DRAFT SAFETY EVALUATION REPORT  
ON  
CHAPTER 19 OF  
THE GENERAL ELECTRIC COMPANY'S APPLICATION  
FOR CERTIFICATION OF THEIR  
ADVANCED BOILING WATER REACTOR DESIGN

prepared by the  
Office of Nuclear Reactor Regulation  
U.S. Nuclear Regulatory Commission  
September 1991

Figure 19.4-1 ABWR Seismic Hazard Curve

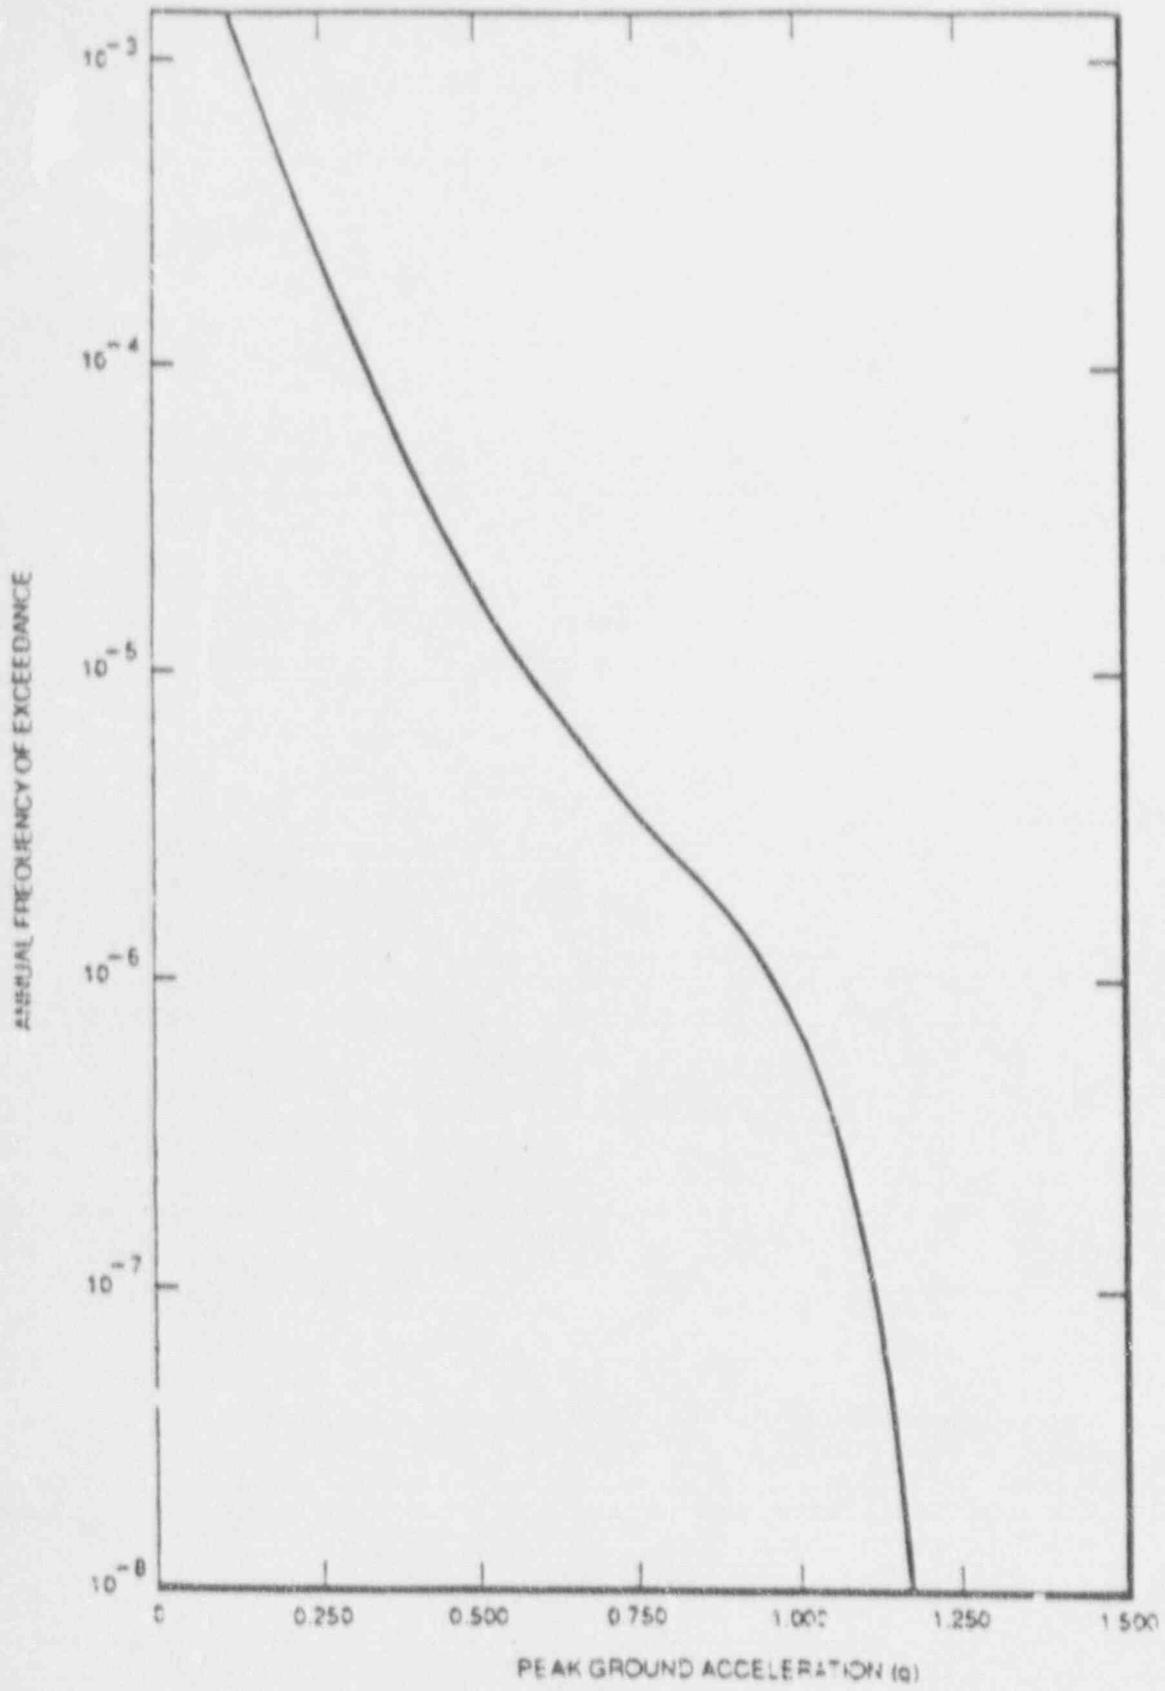
This hazard curve (Fig. 19.4-1) was shown in the GESSAR II seismic event analysis to be a bounding curve of the best-estimate hazard curves for the Limerick, Indian Point, Zion, and Oyster Creek sites based on the information available at that time. For the ABWR application, this curve was further compared to the median hazard curve of the Oconee site and found to be bounding (see GE's response to staff question 725.68, Reference 19.56). The soil-structure interaction effect on seismic risk is not included in the hazard curve but is treated in the seismic fragility estimate.

Figure 19.6-2 GE's and the staff's breakdown of the conditional probability of accident progression groups given core damage for seismic events.

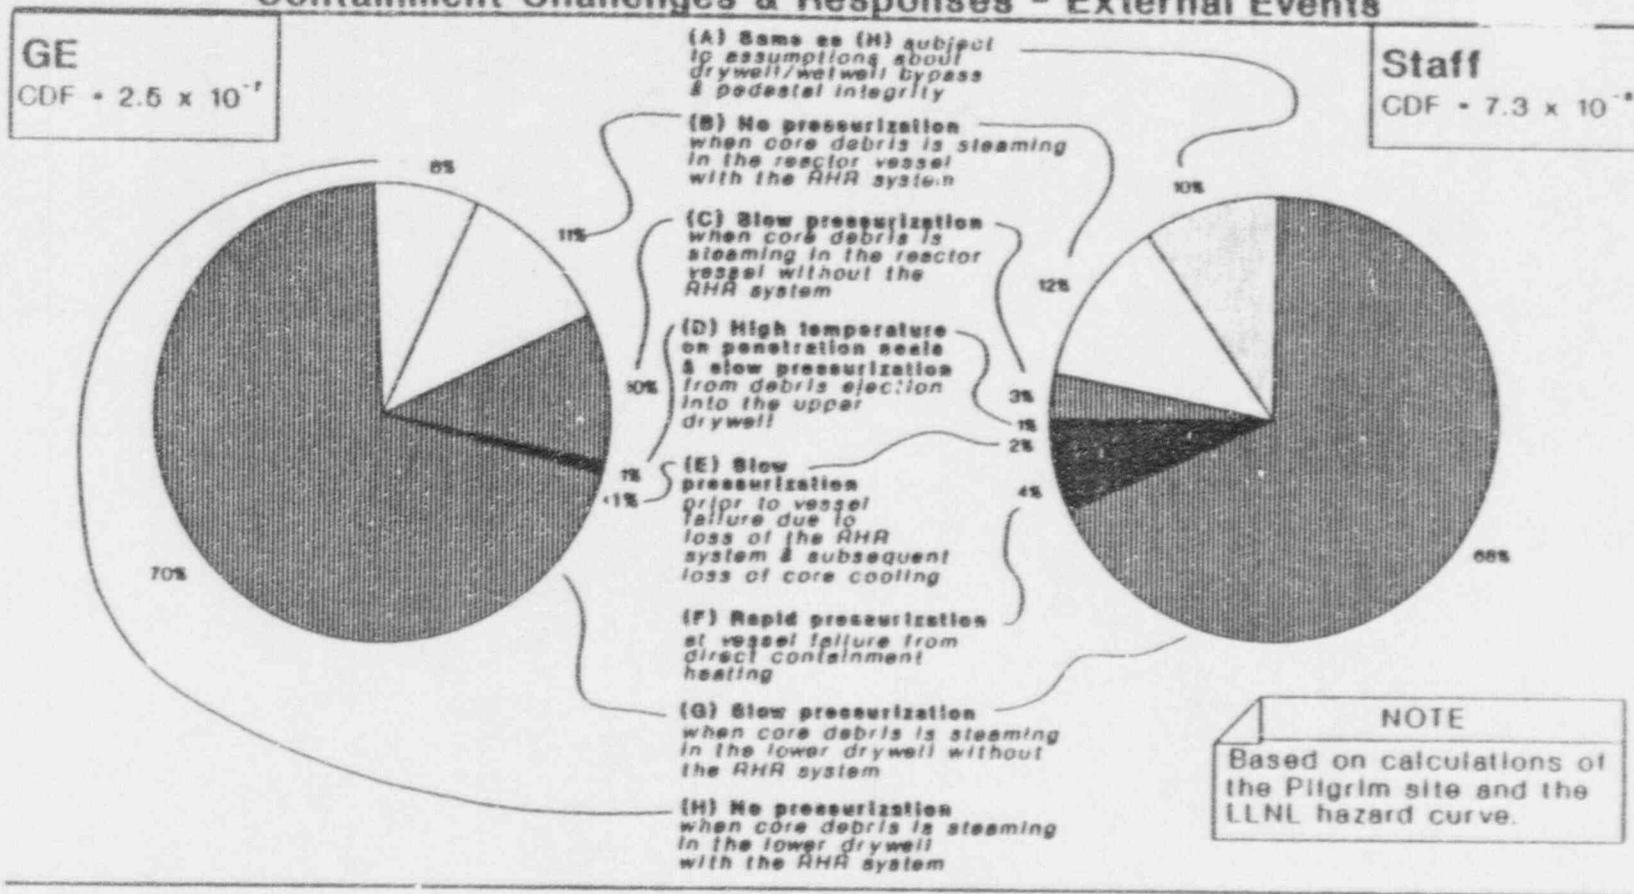
In Figure 19.6-2, the frequency of accident progression groups of the staff's analysis is the result of using the Pilgrim site with its LINL hazard curve, selected because this gives the highest core damage frequency of the staff's six seismic analyses.

In the seismic events analysis, Figure 19.6-2 shows much less improvement in risk because of the modification. Here, the primary reason for the failure of the containment is the loss of the RHR system. This causes slow pressurization, which led to vent actuation.

Figure 19.6-1 GE's and the staff's breakdown of the conditional probability of accident progression groups given core damage for Internal events.

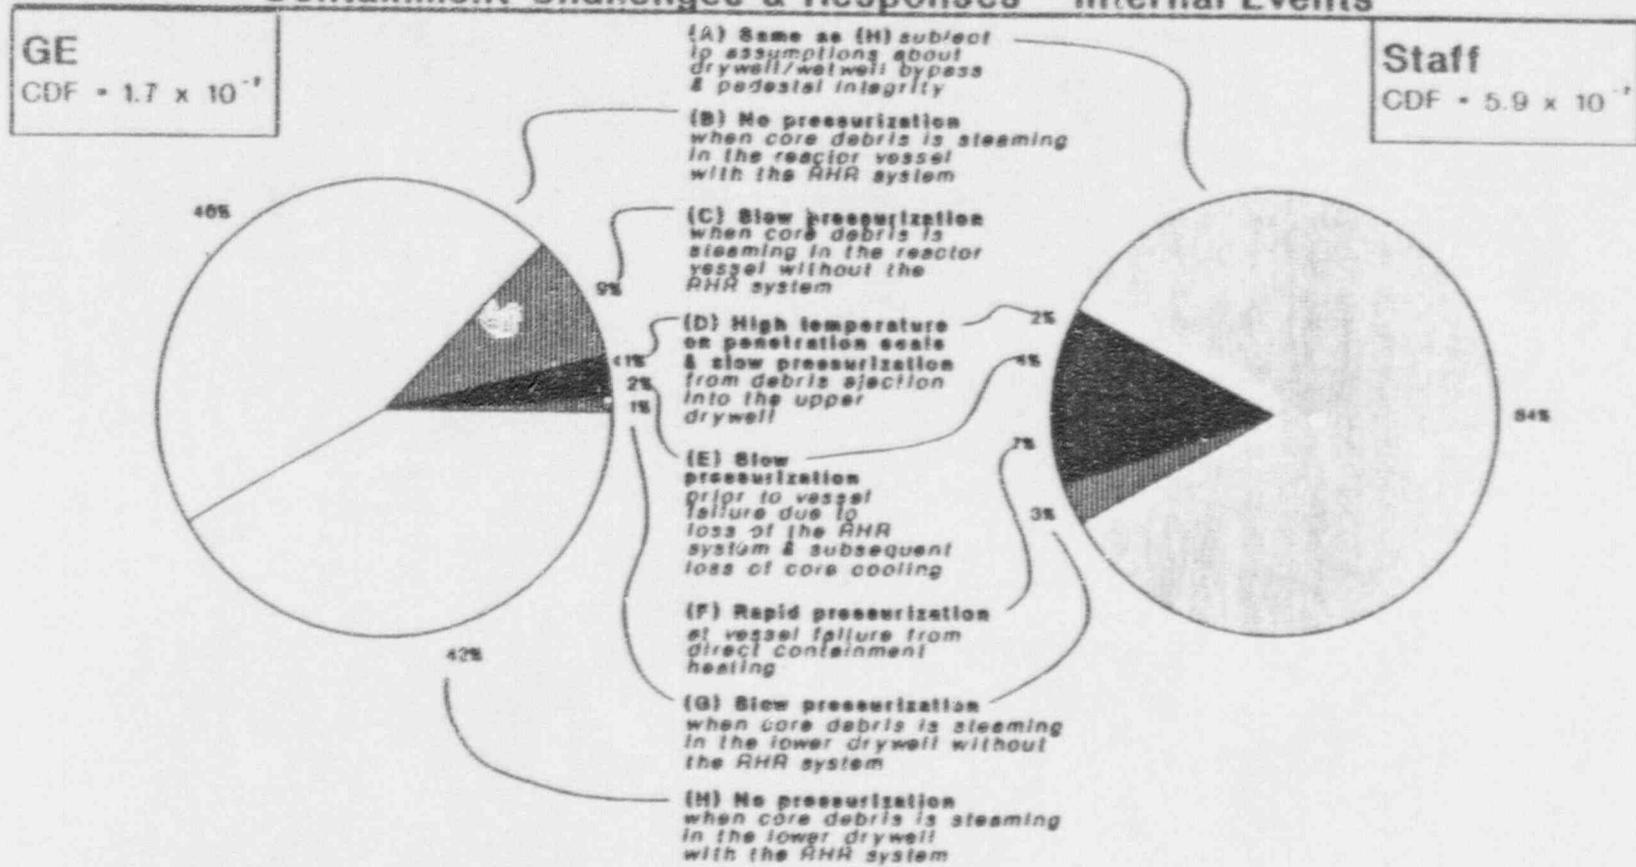
Given the assumptions noted in the Group (A) description of Figure 19.6-1 and the above definition of containment failure, the point estimate of the total conditional containment failure probability (CCFP) for internal events is 16 percent in the staff's analysis and 12 percent in the GE analysis (i.e. Groups (C), (D), (E), and (G) in Figure 19.6-1); the difference is mainly due to the consideration of direct containment heating in the former analysis. The conditional containment failure probability for early failures in the internal events analysis is predicted to be 13 percent by the staff and 3 percent by GE (Groups (D), (E), and (F) in figure 19.6-1). For external events, the point estimate of the total conditional containment failure probability is 78 percent in the staff's analysis and 82 percent in GE's analysis. The higher conditional failure probabilities in the seismic events analysis relative to the internal events analysis are largely due to the assumption in both the GE and staff analyses that the loss of power is non-recoverable after a seismic event. Note that the GE values reported above incorporate corrections to a number of arithmetic and logic errors identified through the staff's review. Hence, these values differ from the (uncorrected) GE point estimates presented in Table 19.9-1.

Figure 19.6-1 (see Internal Events as analyzed by the staff) shows that containment failure from rapid pressure pulses due to direct containment heating accounts for 7 percent of the accident progression frequency; this assumes the modified ABWR having an ultimate containment strength of 134 psig. In the unmodified design having the ultimate strength at 100 psig, the containment failed in sequences contributing about 13 percent of the accident progression frequency. Therefore, this modification of the containment reduced the conditional early containment failure probability by approximately half (from 13 to 7 percent). Incremental increases in strengthening the containment would further

Figure 19.6-3 Schematic diagram of the ABWR containment.

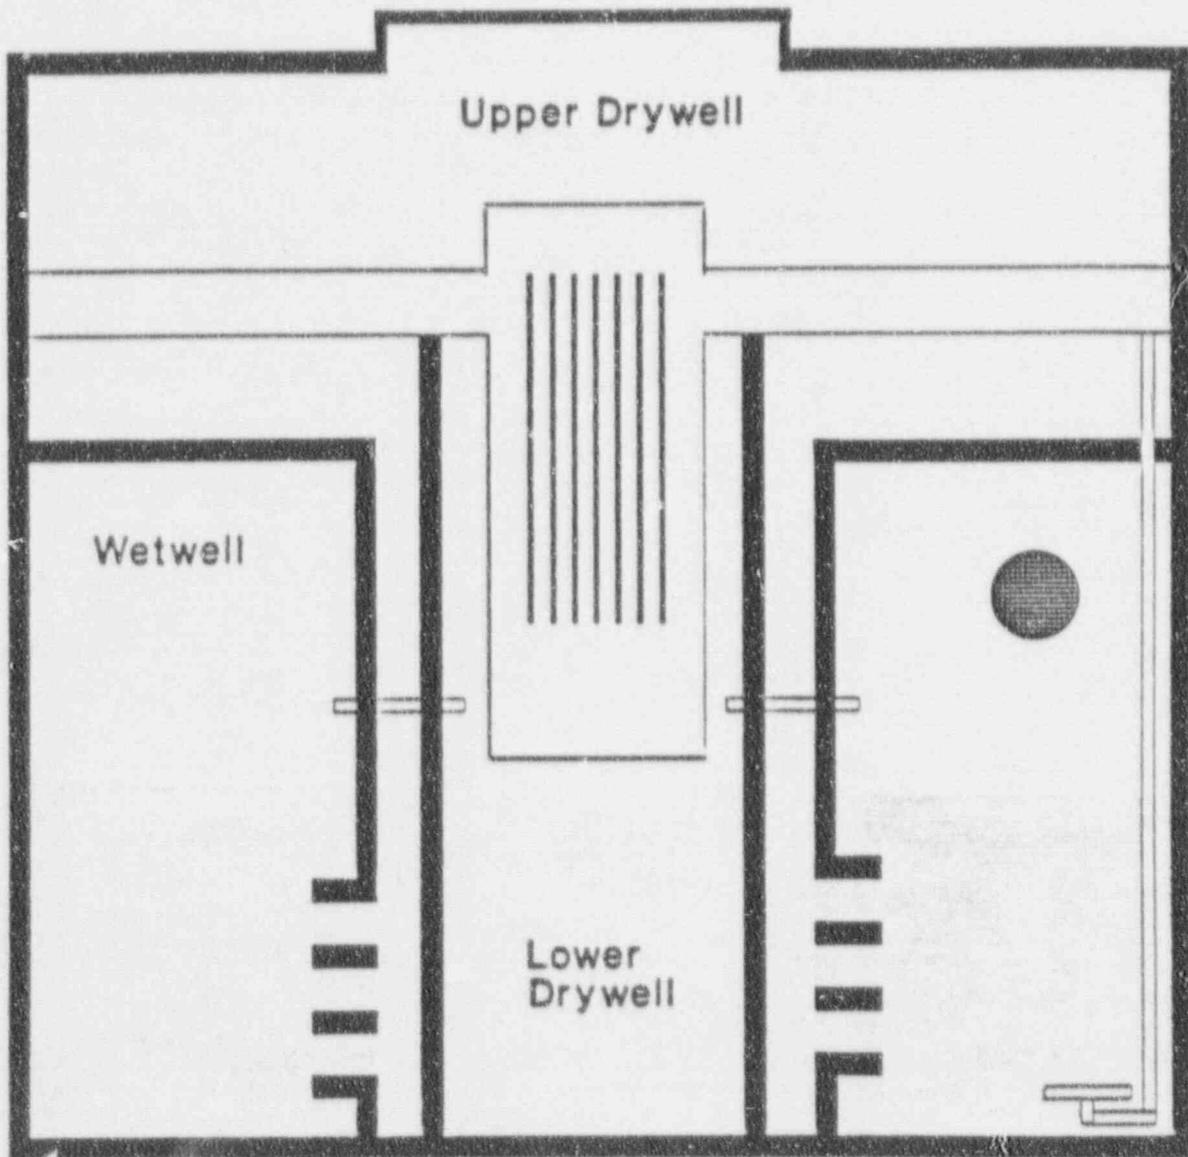
Figure 19.6-3 is a schematic diagram showing features of the ABWR containment relevant to drywell/wetwell bypass. Figure 19.6-4 illustrates the bypass issue by showing the containment pressure as a function of time for various bypass flow rates in the ABWR. The figure was generated with equations that yield only a first approximation to the expected pressures and suggests that bypass flow rates must not be allowed to exceed those values that could compromise the integrity of the containment system, i.e., early vent actuation followed by frequent manual opening thereafter. The relationship between flow rate and  $A/K^{1/2}$  shown in Figure 19.6-4 was obtained from data and analysis performed in the NUREG-1150 study of the Grand Gulf plant (Reference 19.62). Figure 19.6-4 is based on

The staff has concluded that Gd should provide a comprehensive assessment of the risks associated with drywell-to-wetwell bypass leakage. Such an assessment should include complete consideration to such matters as (1) the basis to support an allowed leakage area ( $A/K^{1/2}$ ), and (2) the basis to support an expected leakage area during the course of a severe accident when the vacuum breakers would be required to perform several times in a severe environment. This is an outstanding item.

Figure 19.6-4 Wetwell pressure as a function of bypass flow (CFM) and time (hours).

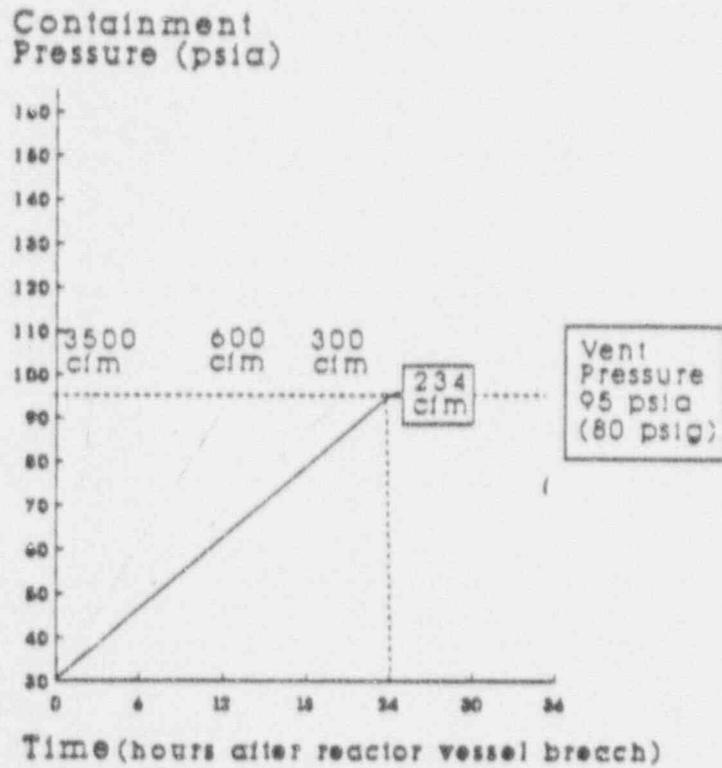
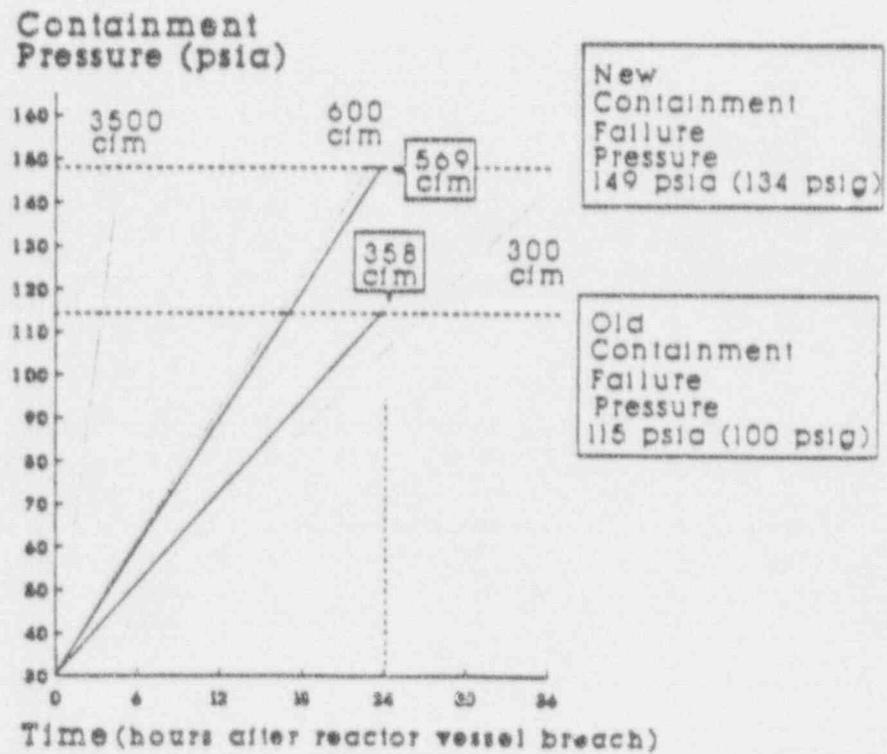
The effectiveness of the vent can be severely compromised unless drywell/wetwell bypass is controlled. Because the setpoint of the vent actuation is lower than the ultimate strength of the containment (Figure 19.6-4), the overpressure protection system may merely open the containment earlier than had it not been present. For more discussion about drywell/wetwell bypass, see Section 19.6.4.2.1.

system, taking into account downside risks, and carry out the necessary analysis of the effects of drywell/wetwell bypass on risk before conclusions can be reached that the system has a net benefit from a risk perspective.

Figure 19.6-5 Hypothetical distributions illustrating the uncertainty in the vent setpoint and the containment failure pressure.

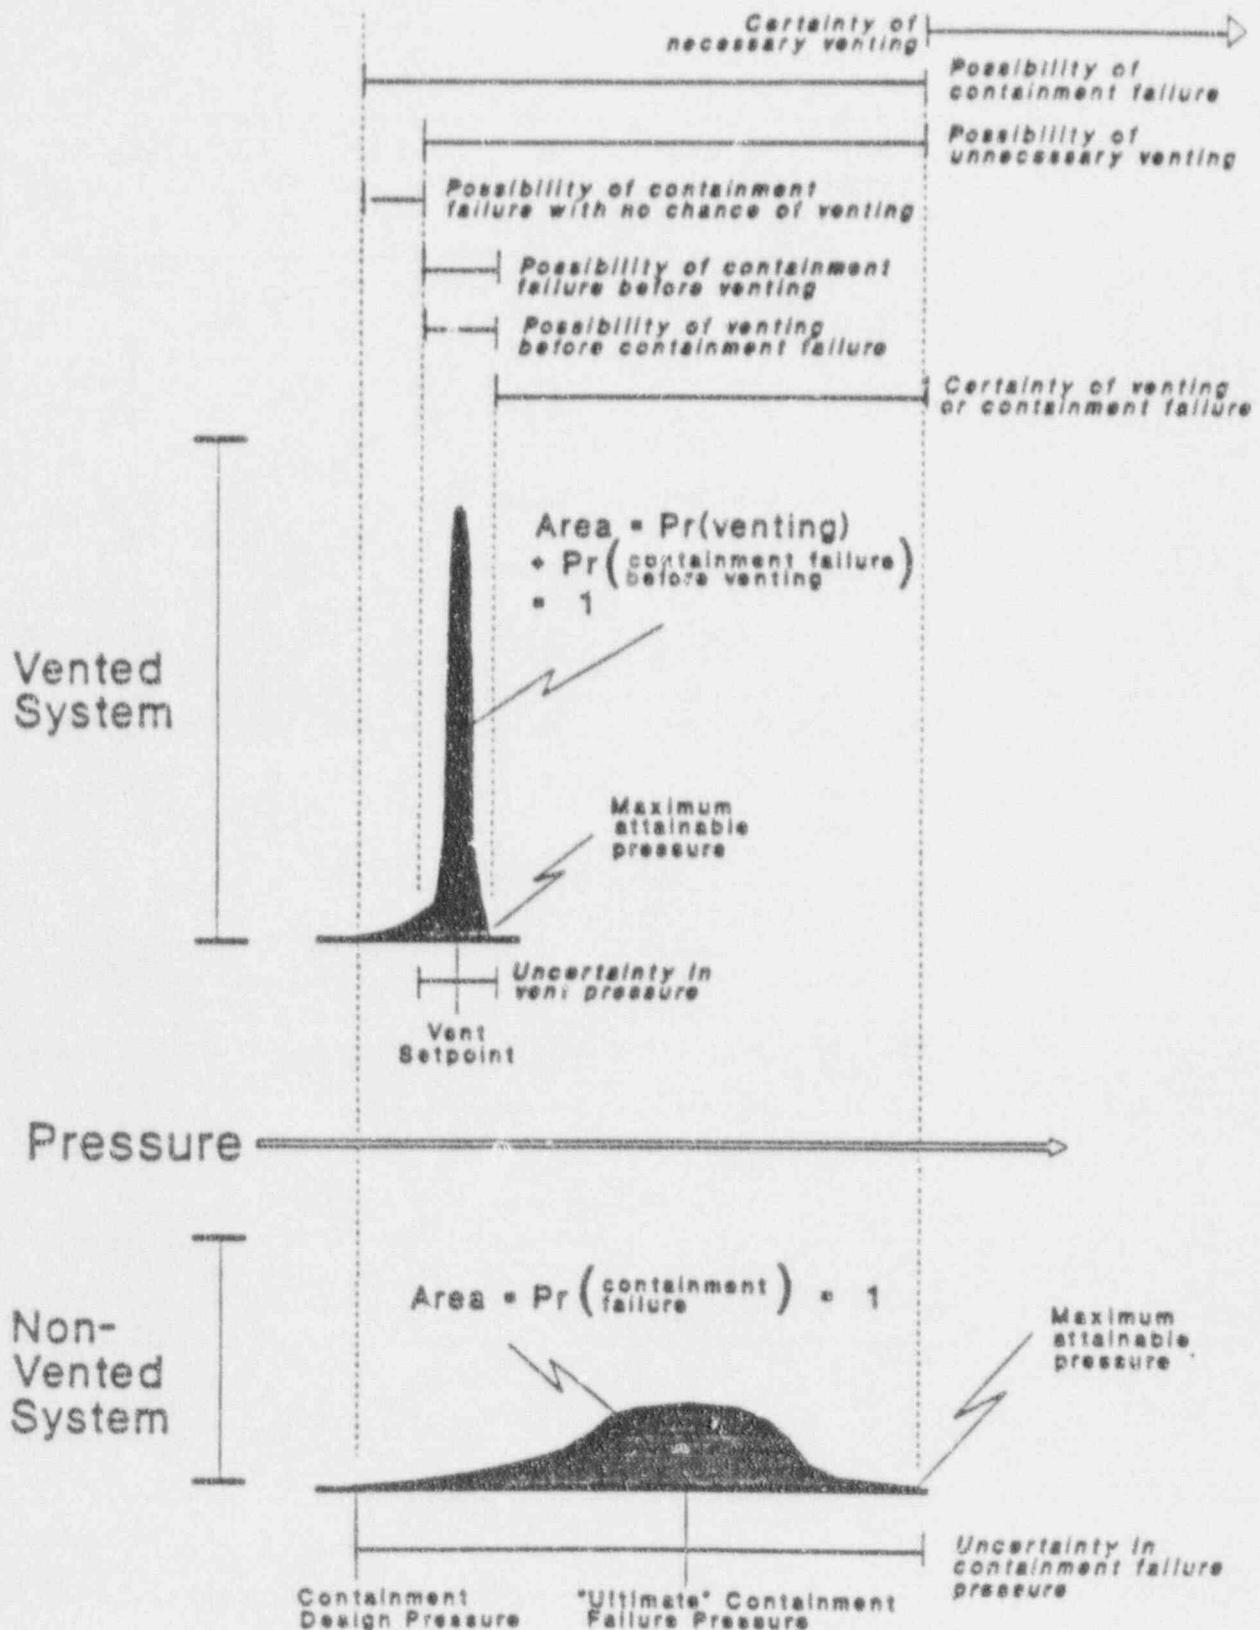
In its analysis, the staff has identified the trade-offs assuming an all-or-none behavior of containment structural failure and an initial attempt to quantify the effects of the bypass on the efficacy of the overpressure protection system. Based on the review, the staff believes that GE should justify the setpoint of the overpressure protection
